SYSTEM/MODEL: LEF

MODIFICATION: Convert privacy switch to full time privacy mode

REFERENCE DRAWING #: 0798-1316

MODIFICATION INSTRUCTIONS

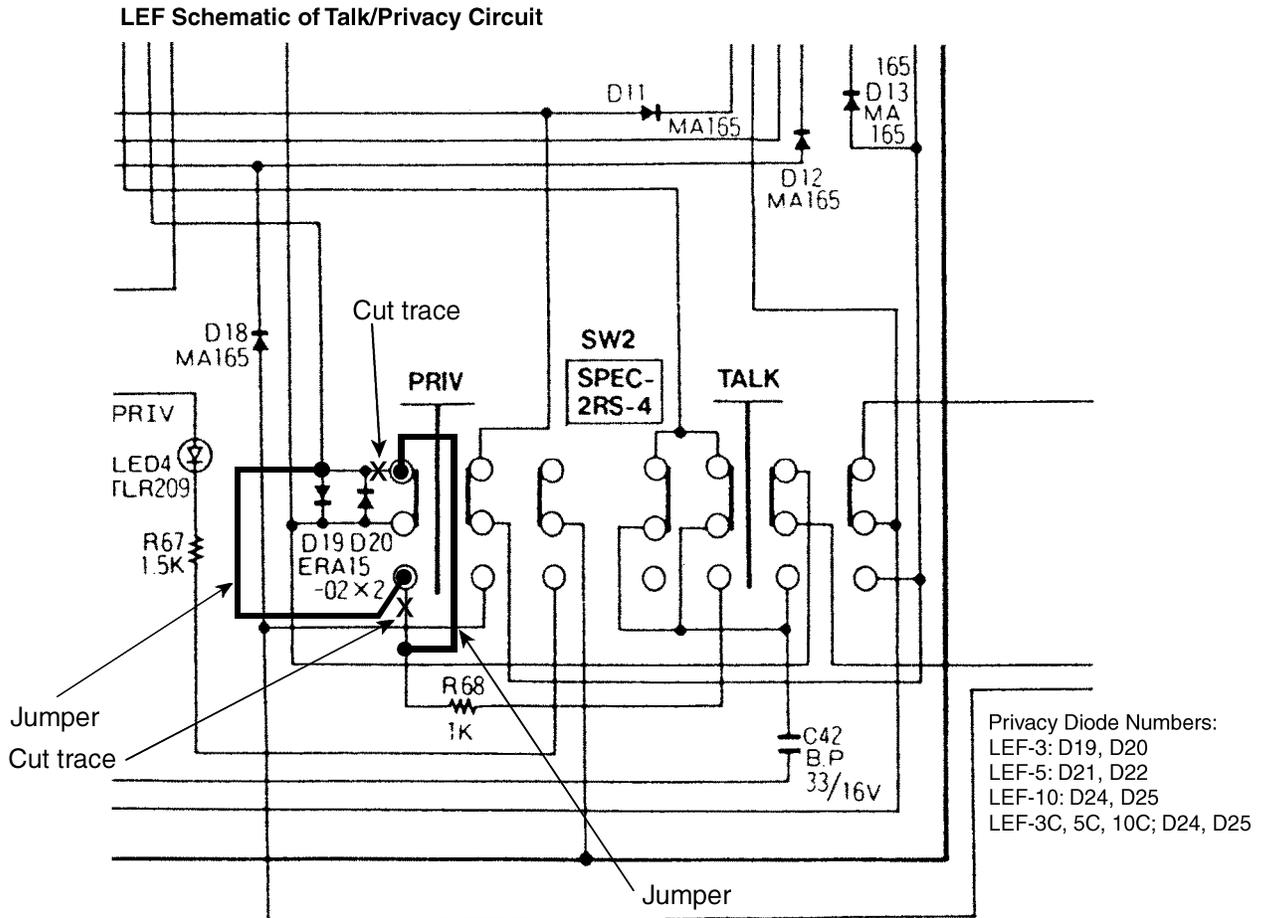
INSTR/OPERATIONS: 1. Install jumpers and cut traces as shown on the following schematic.

Solder two jumpers in place as shown above.
Cut traces where marked with an "X".

INSERT SMALL SCREW (1mm) in the hole between the TALK and the PRIV switch to make the privacy button momentary instead of locking. (Sub-plate inside switch must be held to the right.)

This modification will put the master station in the privacy mode all of the time. To respond to a call from another master, press the *PRIVACY* switch to talk, and release to listen.
